Fire Risk Assessment

Hazelwood School

21 Oct 2025

Ian Meares AIFireE

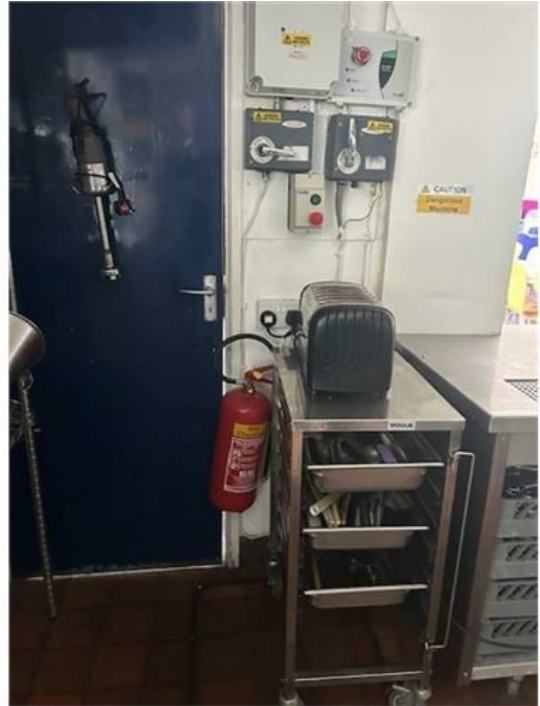
Ref	Sub Section	Question	Non-conformity	Recommendation	Location	Who is responsible	By When
13708124	11.0.N	Are there adequate and suitable fire safety signs and notices displayed in the appropriate places throughout the premises?	The portable firefighting equipment is not identified by appropriate signage to show its location and fire classification. The Fire Blanket in the kitchen has no sign and Wet chemical extinguisher signs are obscured by kitchen items.	Portable firefighting equipment type and location should be identified by appropriate signs which conform with BS 5499-5.	Kitchen in dining room building	Statutory requirement of the Client	18/12/2025

Hazel Main combustibles on escape route.jpg

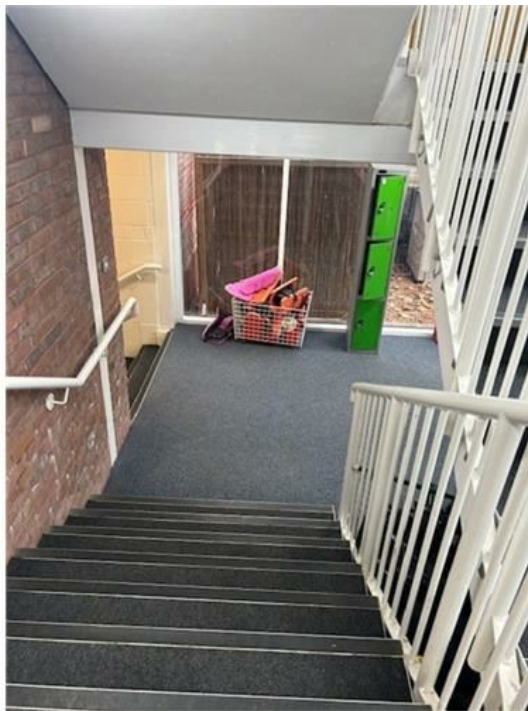
Ref	Sub Section	Question	Non-conformity	Recommendation	Location	Who is responsible	By When
13708111	A	Are house keeping arrangements satisfactory?	Combustible materials are located/stored in the escape routes. 1- Bailey protected staircase. 2- First floor Main building store room adjacent to M7. 3- Theatre/Chapel protected staircase 4- Protected staircase around the sports hall.	Items that are a source of fuel or are combustible and likely to increase the fire loading or spread of fire, should not be located on any corridor, stairway or circulation space that will be used as an escape route. Therefore, the combustible materials stored in the escape routes must be removed. Room close to M7 should have its Fire Door re-instated.	Bailey protected staircase. Main building near M7. Theatre protected staircase. Sports hall protected.	Statutory requirement of the Client	18/12/2025
